BEECROFT CHELTENHAM CIVIC TRUST INC

BULLETIN 4

Special Issue - Epping to Thornleigh Third Track Oppose this Project which will destroy Beecroft and Cheltenham A Submission Form for you to sign is on Page 4

What is wrong with the Epping to Thornleigh Third Track (ETTT) Proposal

Figure S.5 Artist's impression of new elevated concourse at Cheltenham Station looking south from The Crescent (indicated by red dot)

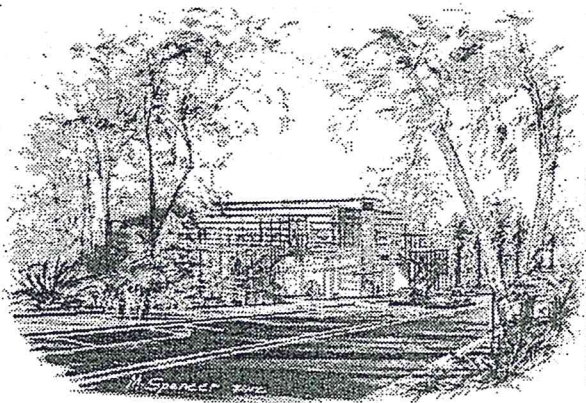
The ETTT proposal imposes a two storey, 13m high, railway concourse at Cheltenham to be positioned near the entrance to the current car park. It will have lift and stair access to all platforms, a bus bay and taxi rank. The indicative design shown in the EIS is a glass and steel structure. This is totally inappropriate for a Heritage Conservation Area and indicates that the designers either ignored or were unaware of the HCA. The only time buses come to Cheltenham Station is when they are replacing rail. There has never been a taxi rank at Cheltenham, nor any need for one.

The EIS considers that this huge structure is *'unlikely to have significant impacts on the heritage values'* of the houses opposite, mainly because some of them will be screened by vegetation.

- The proposed redevelopment of Cheltenham Station shows no regard for the HCA. The visual impact of the proposed 13m high glass and steel concourse is totally unacceptable in this HCA.

Figure 5.3 Future Cheltenham Station layout

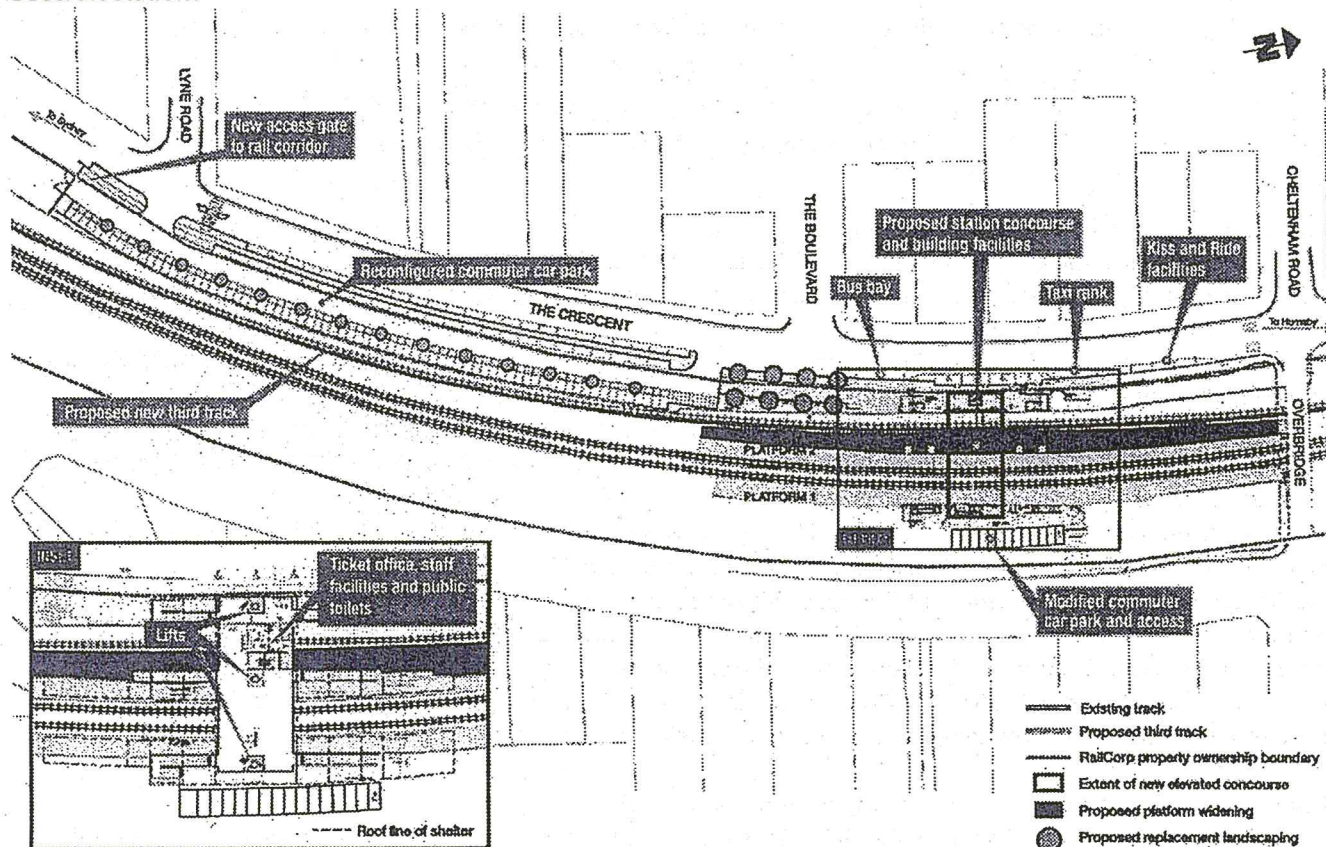
The car park on the western side will be extended almost to Lyne Road which will increase walking distance and impact on the Cheltenham Recreation Club. Parking in The Crescent adjacent to the station is removed.

There has been little or inadequate consideration of aboriginal artefacts known to be in the area.

Rock will be removed from the cutting under the western side of the road bridge which will be strengthened.

Why is this work proposed for such a quiet station when little enhancement is proposed for the much busier Beecroft station?
